MEMORANDUM

From:	Built Heritage Officer		
Service	Green Infrastructure	App No:	242872 + 242873
Address:	The Swan, Basingstoke Road, Three Mile Cross, RG7 1AT.		
Proposal:	242872: Full application for the proposed demolition of rear extensions preceding the erection of new single storey extension. Addition of pergola and pathway from carpark to new entrance, including associated landscaping. Replacement of existing boundary wall. Removal of existing storage outbuilding. Installation of new driveway. 242873: Listed building consent for the proposed demolition of rear extensions preceding the erection of new single storey extension. Addition of pergola and pathway from carpark to new entrance. Replacement of existing boundary wall. Removal of existing storage outbuilding. Installation of new driveway.		
Heritage Asset:	The Swan – grade II listed building. The Mitford – grade II listed building. Three Mile Cross Area of Special Character – Council identified of non-designated heritage asset status. Listed buildings are classed as designated heritage assets under the NPPF (2024) and in the Council’s Local Plan policies.

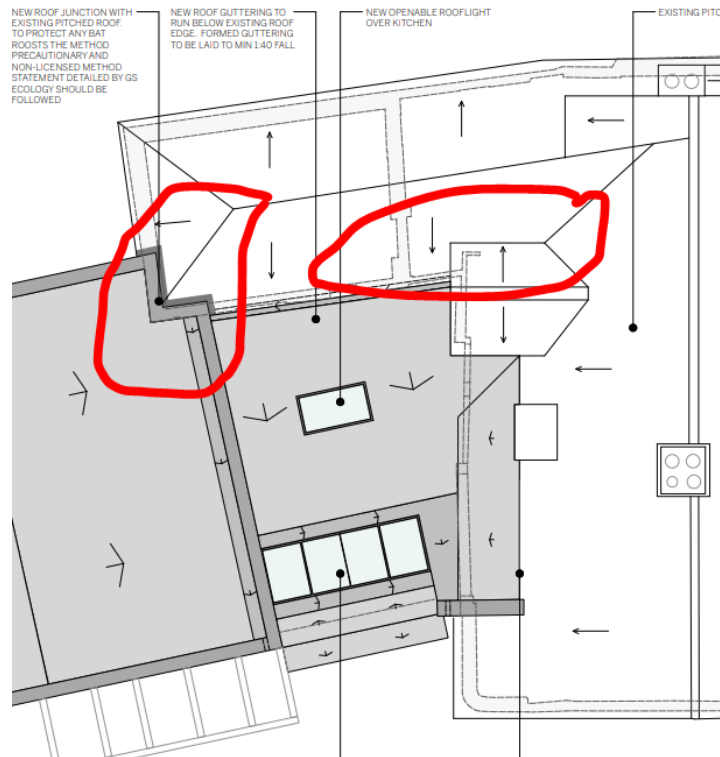
The aerial photograph shows a flat roof fillet to southside of asymmetrical pitched roofed dormer not shown on roof plan. Other highlighted area is the overlap of new extension to SE corner of rear range.

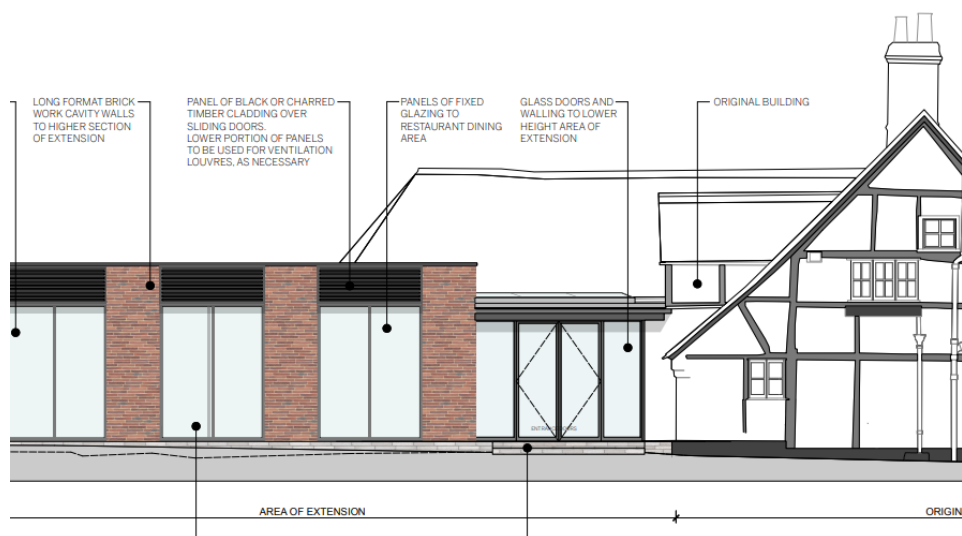
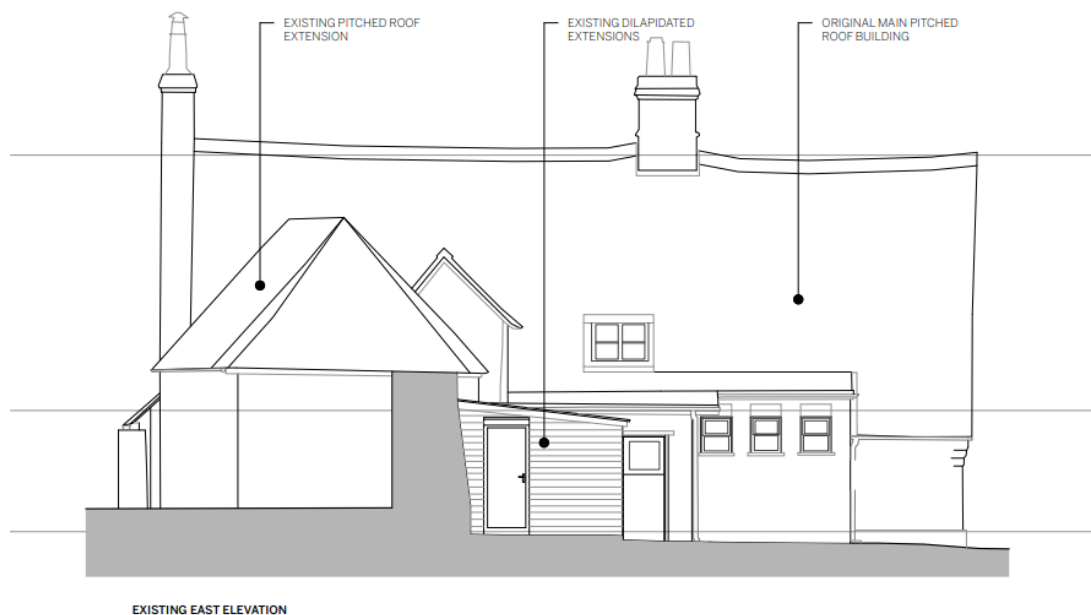
Both existing and proposed north elevation drawings do not show the small flat roofed dormer that is thought should be visible in these views.
